01 SITE PLAN
 1" = 50'-0"

DISD - W.W. BUSHMAN REPLACEMENT ELEMENTARY SCHOOL

ZONING CASE # Z 212-271

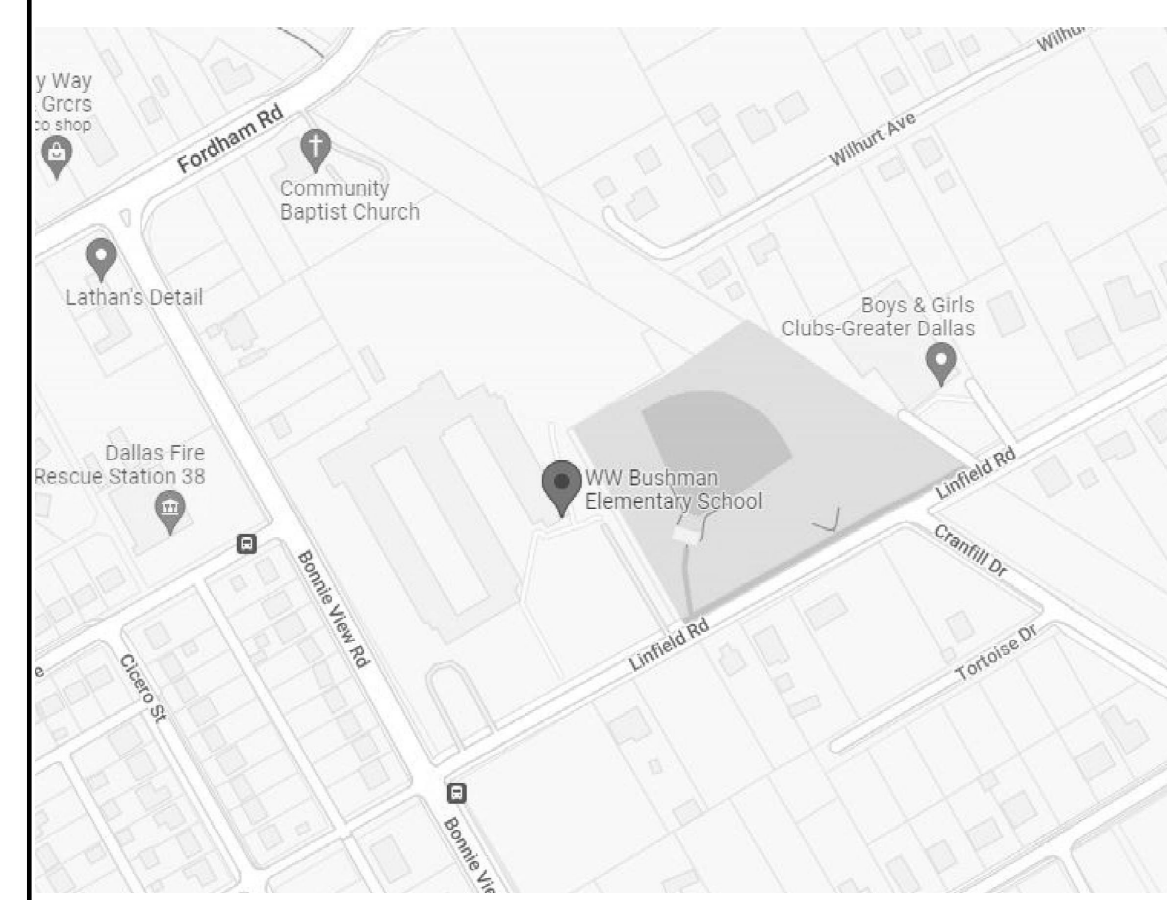
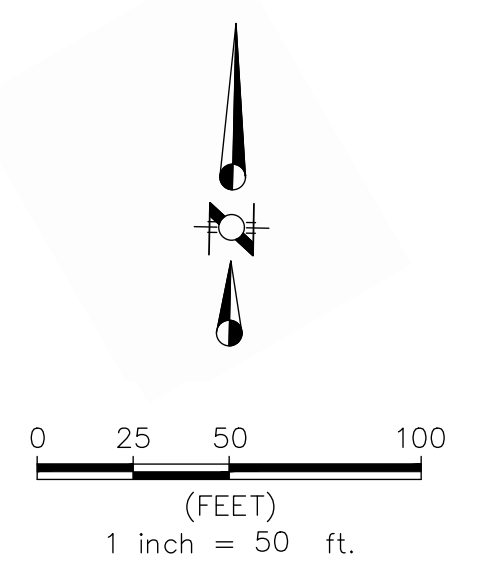
Staff recommendation:

1. ADD PAVED PEDESTRIAN PATH ALONG CIRCUITOUS DRIVEWAYS AND/OR PEDESTRIAN ROUTES THROUGH THE CAMPUS FROM ALL ACCESS POINTS. SPECIFICALLY, STAFF RECOMMENDS THAT THE PAVED PEDESTRIAN PATHWAY FROM THE INTERSECTION SHOWN IN THE NOVEMBER 17, 2022, VERSION OF THE TMP (DISTRIBUTED TO COMMISSIONERS ON THAT HEARING DATE) BE REINSTATED AS PART OF THE PROPOSAL. STAFF NOTES THAT REMOVAL OF THE PATHWAY AS SHOWN HERE WILL NOT PREVENT CHILDREN FROM CROSSING THE SERPENTINE QUEUE LANES, PARTICULARLY AT ARRIVAL; IT JUST REMOVES THE DESIGNATED PATHWAY FOR DOING SO IN THE SAFEST POSSIBLE MANNER AND WITH SUPERVISION BY AN ADULT.

2. STAFF HAS ADDED REVISED SIDEWALK/BUFFER LANGUAGE AS A RECOMMENDED SUP CONDITION.
3. STAFF HAS ADDED PEDESTRIAN AMENITIES LANGUAGE FOR BENCHES, TRASH RECEPTACLES, AND BIKE RACKS AS A RECOMMENDED SUP CONDITION.

4. PEDESTRIAN SCALE LIGHTING IS ALSO RECOMMENDED TO BE ADDED AS AN SUP CONDITION.

Staff comment:
 TABLE HAS INCORRECT DATA. CONFIRM THE MATH AND CORRECT THE DATA.
